Planning Commission

Wednesday, May 3, 2023

**TECHNICAL REVIEW PLAT REQUIREMENTS
REGULAR PLANNING COMMISSION MEETING
MAY 3, 2023**

Preliminary Plat
WHITECAP
NORTH PADRE ISLAND

PHASING & STREET RIGHT-OF-WAY PLAN

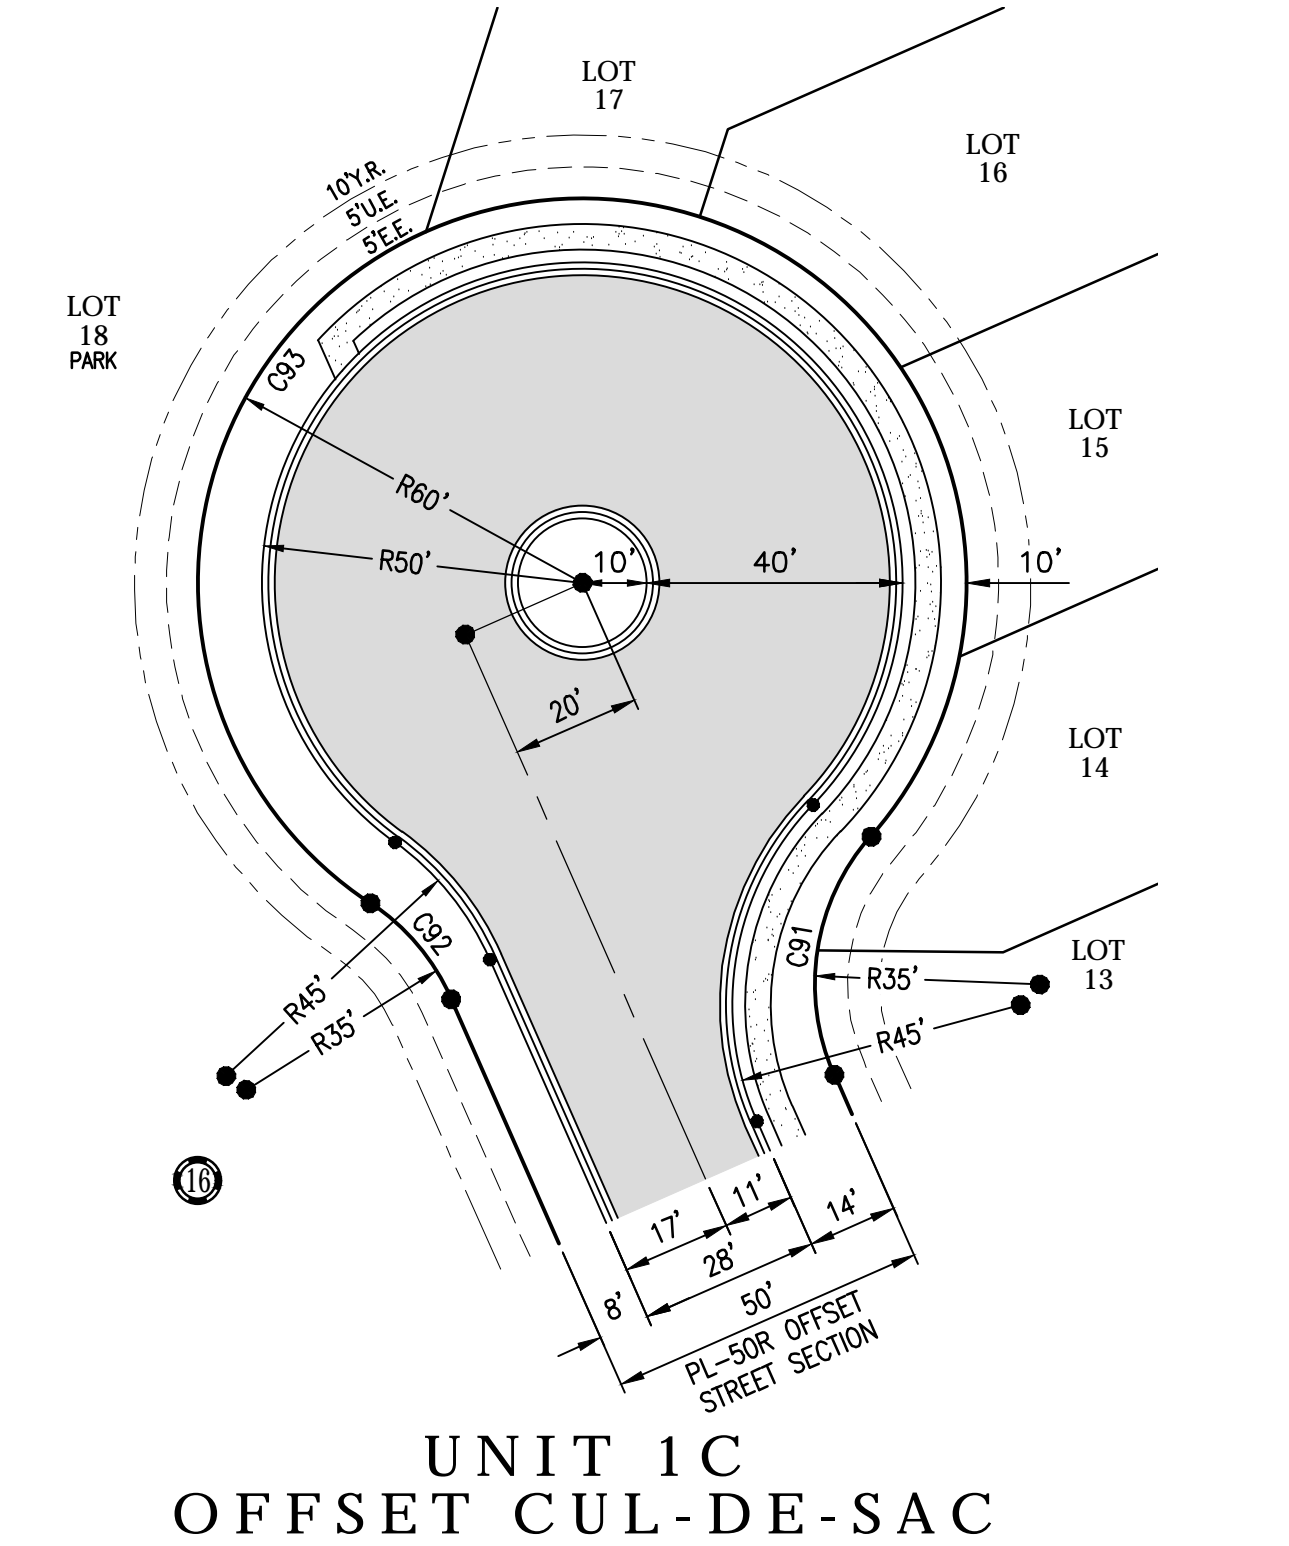
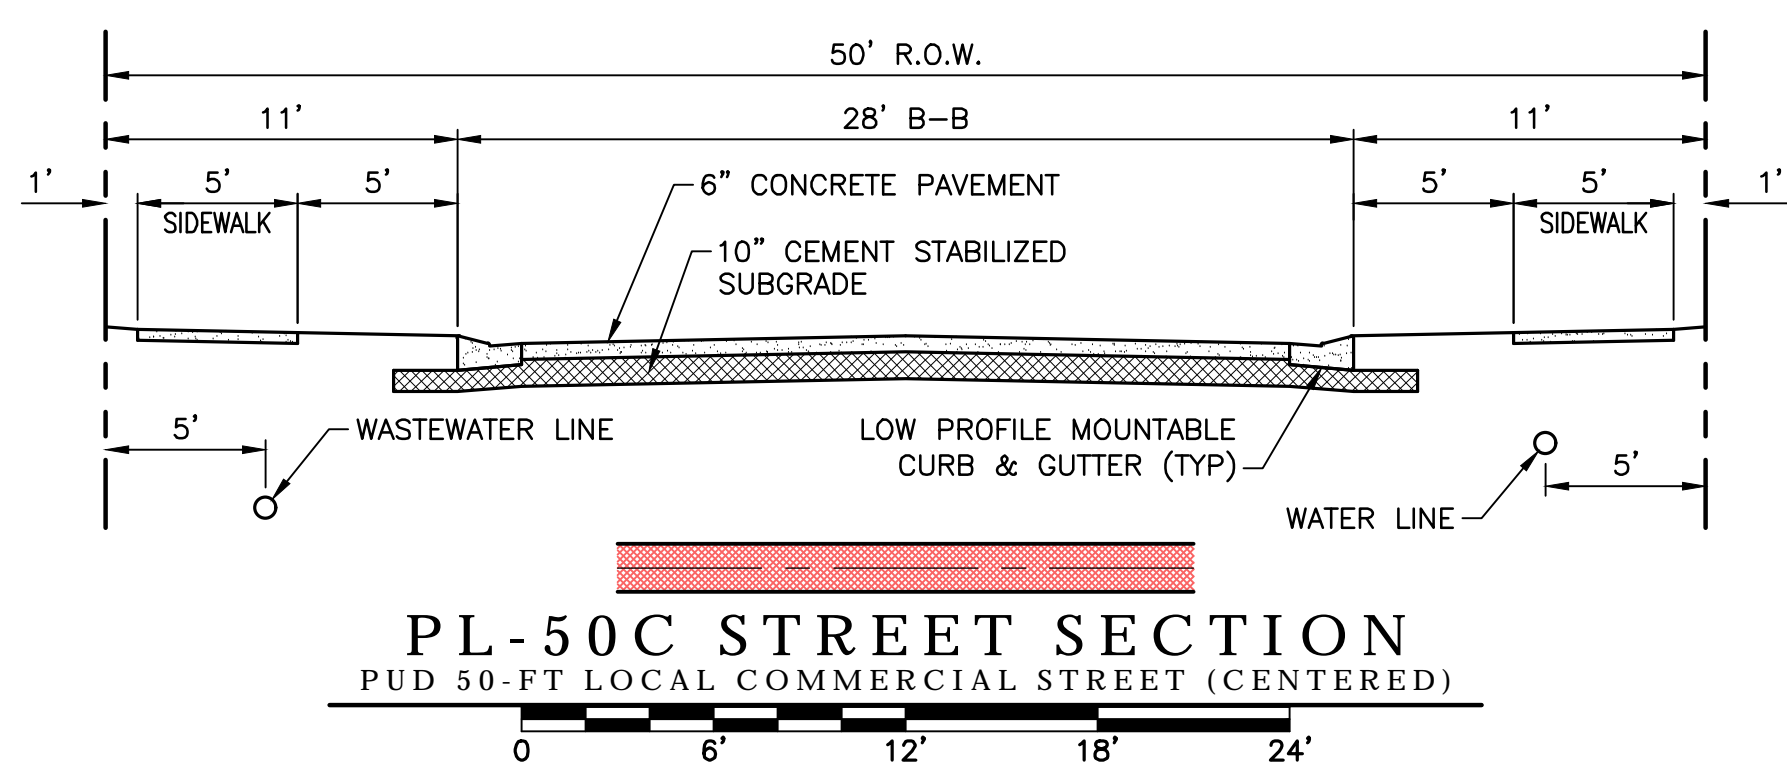
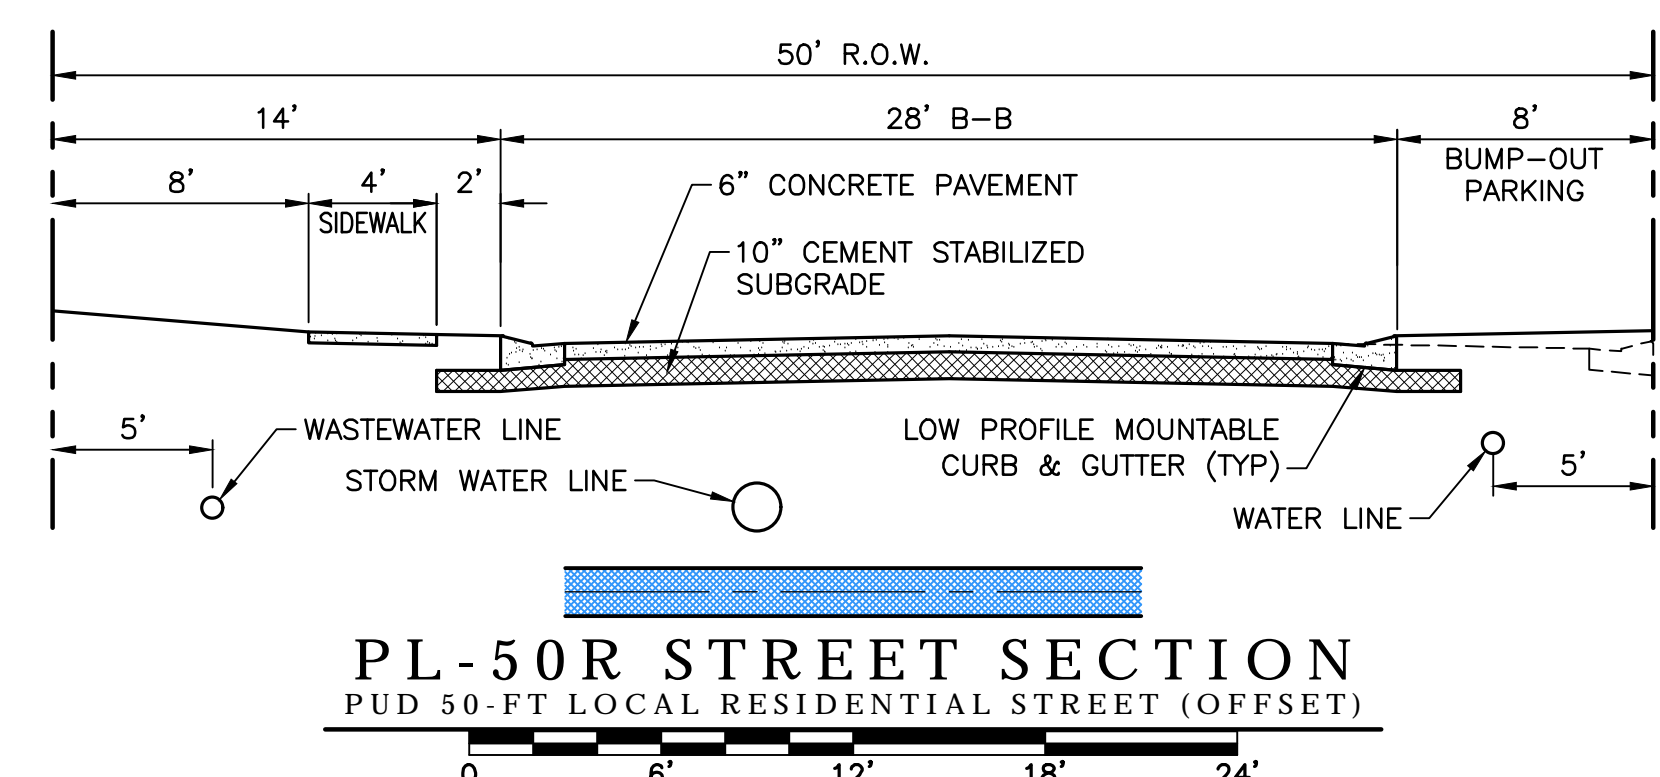
6	Plat 2	Provide Bold type labels for each phase Unit within each Unit boundary for each sheet.	Complete.	Addressed		
6	Plat 2	Provide Flood plain boundaries with labels on plat or verify Plat note 2 indicating entire property is in AE zone. Provide contours in light weight lines on plat.	Complete, noting that the addition of contours necessitated the addition of the existing bulkheads. Additionally, note that the plat displays the contours following the Site Work improvements that are currently nearing completion, while the SWQMP displays the pre-existing contours.	Not addressed. New construction contours to be on Public Improvement plans (Remove from plat). Existing contours requested are by the Prelim plat application checklist. Remove floodplain boundaries from Sheet 1 Phasing Plan. See previous submitted Sheet 1. Do not change as submitted.		
6	Plat 2	Provide legal description, ownership and recording information for adjacent south and north adjacent	Complete.	Addressed

7	Plat 2	Provide "Private Park" label for Block 5, Lot 2 & 3. Provide "Private" to all Park lots on all sheets.	"Park" label added. General Notes on Sheet 1 designate all parks as private.	Not Addressed. Label as "Private Park" on plat.		
8	Plat 2	Provide lot and block number for Navigable Channel. Area to be included in Final plat and recorded as a Lot. Square footage should be provided. Include Navigable channel to note 8 and additional requested on LD comment #5.	This plat is notated and numbered in accordance with the precedent set by the existing island subdivisions (e.g., see Coquina Bay, Barataria Bay, Point Tesoro, Ports O' Call, etc.). Square footages of Navigable Channels have been added within the plan. Note that assigning lot numbers would 'tie' blocks together across the channels, for example, converting the channel between Units 1A and 1E to a lot would combine Blocks 1, 2, 12, & 14 into a single block. And to the extreme, numbering the channel east of Phase 1B would combine Blocks 7, 11, 15, 16, 17, & 46 into a single block spanning Phases 1B, 1C, 1D, and 1E.	Addressed; further maintenance obligation to be on Developer Agreement.

9	Plat 2	Adjacent easements to shown and labeled for adjacent properties. (10' UE along Aquarius St. and on north border).	Complete.	Addressed		
	Plat 2	Previous plat references 7.5' UE crossing Unit 1A and 1E. Indicate whether it is closed. If not, then Easement closing by separate document will be required prior to Final plat recording.	Acknowledged.	Addressed		
10	Plat 2	Proposed bio swales to be in Private Drainage Easements labeled on the plat.	Complete. See Land Development Comment 3 above.	No Addressed. Label as "Private DE" on plat.

11	Plat 2	Lift stations and WW lines to be in easements, whether in Private UE or public UE.	Utility Easements have been added to all lines and will Lift Station easements will be added during the Final Platting/Construction Drawings phase of work to fully encompass the limits of the Lift Station infrastructure.	To be Addressed with Final Plat		
12	Plat 2	Utility lines outside plat boundary to be in an Easement recorded separately and labeled with document number on Final plat. Show easement for force main outside boundary.	Acknowledged, including addition of Offsite Utility Easements for Wastewater, as applicable.	To be Addressed with Final Plat		
13	Plat 3	Provide legal description, ownership and recording information for all adjacent properties on Commodores Dr. and Compass St.	Complete.	For adjacent properties with a recorded plat, only the Subdivision name and volume/page of Plat is required (one label). For properties not platted, the owners name and document number is required for each property. All easements, lot labels, and setback labels should be shown.

(Sheet 4 of 9)

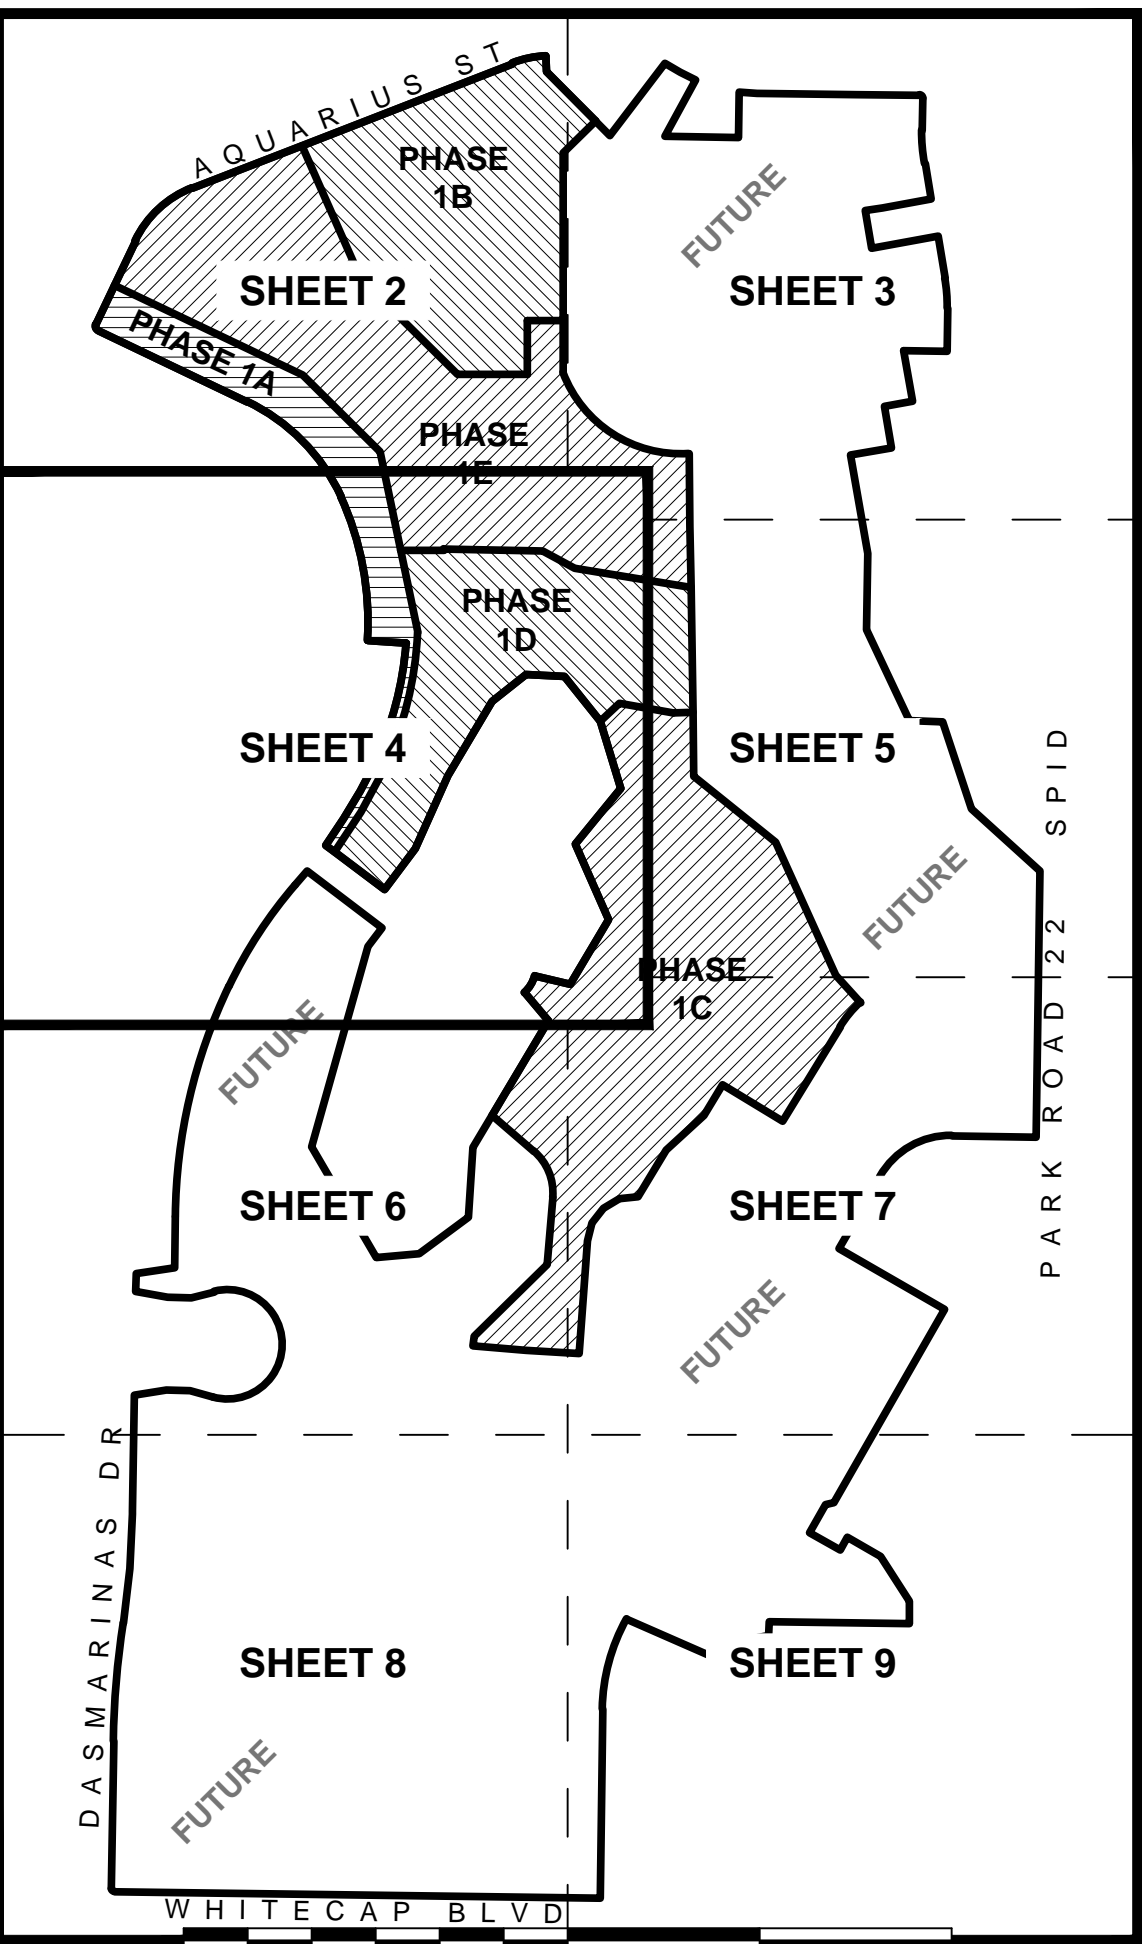
14	Plat 3	Indicate what are the dashed lines parallel with Compass Street. Provide label if need to.	Complete. Labels added.	To be Addressed with Final Plat		
15	Plat 3	Provide and label the centerline for Park Road 22.	Complete.	Addressed		
16	Plat 3	Provide half street distance to platted property for Aquarius St., Commodores Dr. and Compass St.	Complete.	Addressed		
17	Plat 5	Indicate what are the dashed lines parallel with east boundary is for. Provide label if need to.	Complete. Labels added.	To be Addressed with Final Plat		
18	Plat 5	Provide and label the centerline for Park Road 22.	Complete.	Addressed		
19	Plat 5	Provide legal description, ownership and recording information for all adjacent west and east properties	Complete.	For adjacent properties with a recorded plat, only the Subdivision name and volume/page of Plat is required (one label). For properties not platted, the owners name and document number is required for each property. All easements, lot labels, and setback labels should be shown.

(Sheet 7 of 9)

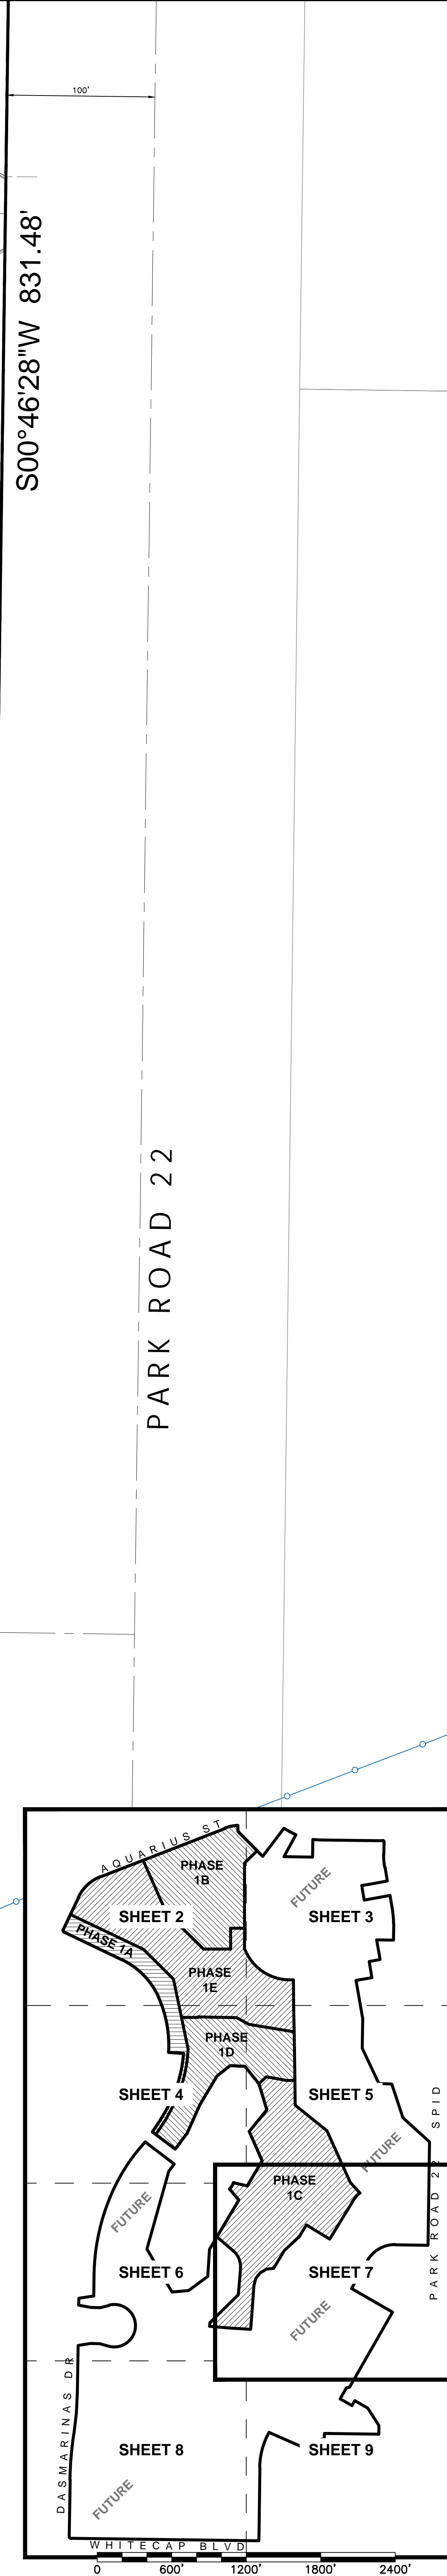
22	Plat 7	Provide legal description, ownership and recording information for all adjacent west and east properties	Complete.	For adjacent properties with a recorded plat, only the Subdivision name and volume/page of Plat is required (one label). For properties not platted, the owners name and document number is required for each property. All easements, lot labels, and setback labels should be shown.		
23	Plat 7	Verify the platted lots (dashed) will be listed on the Final plat description with verification of ownership with application.	Acknowledged.	Addressed		
24	Plat 7	Indicate and label the property whether it is a Private Park or Navigational waters. Provide a Block and Lot number.	Complete.	Addressed		
25	Plat 8	Verify the platted lots (dashed) will be listed on the Final plat description with verification of ownership with application.	Acknowledged.	Addressed		
26	Plat 8	Indicate and label the property whether it is a Private Park or Navigational waters. Provide a Block and Lot number.	Complete.	Addressed
